Monthly Specification Update

Intel® Server Boards S5520HC, S5520HCT and S5500HCV

Intel Order Number E68105-012

February, 2011

27. Intel® Active System Console (IASC) 3.5.1 and 3.5.2 may fail to detect status of memory voltage sensors

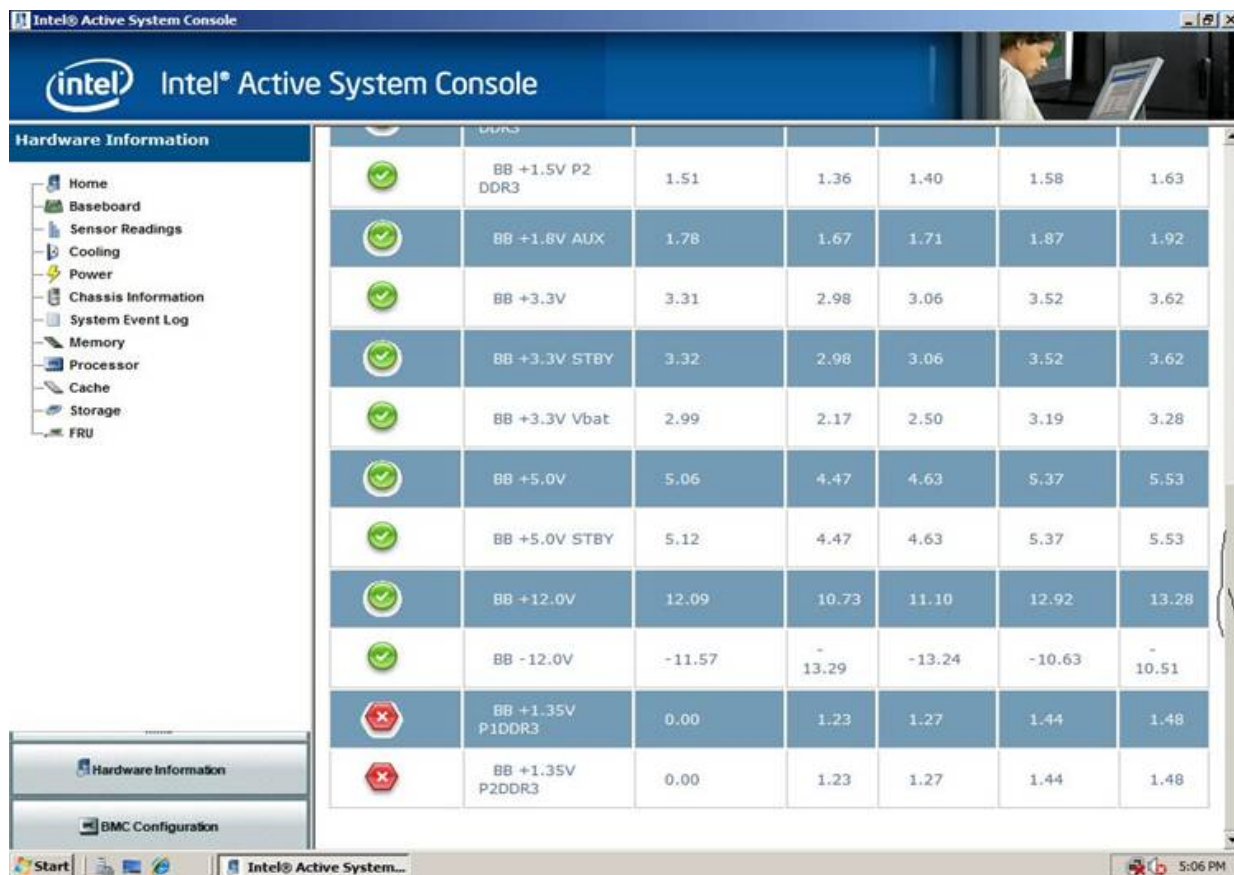
Problem	Intel® Active System Console (IASC) v3.5.1 and v3.5.2 is used to monitor hardware status on Intel server system. Intel® Xeon® 5500 Series Platforms start to support low voltage memory DIMM, so current FRUSDR has contained four memory voltage sensors "BB+1.5v P1DDR3", "BB+1.5v P2DDR3", "BB+1.35v P1DDR3" and "BB+1.35v P2DDR3", When system has 1.5v memory or 1.35v memory, only corresponding memory voltage sensors will be enabled, the other type memory voltage sensors will be disabled. IASC cannot judge the status of memory voltage sensors which have been disabled, and still try to detect those sensors reading. Because sensor reading is "0", lower than its threshold, so IASC shows those sensors status as critical warning. A screenshot of this failure is shown below:
---------	--

Implication IASC fails to judge the status of disabled sensors and still considers those sensors to server health algorithm.

Status This issue may be fixed in future IASC release.
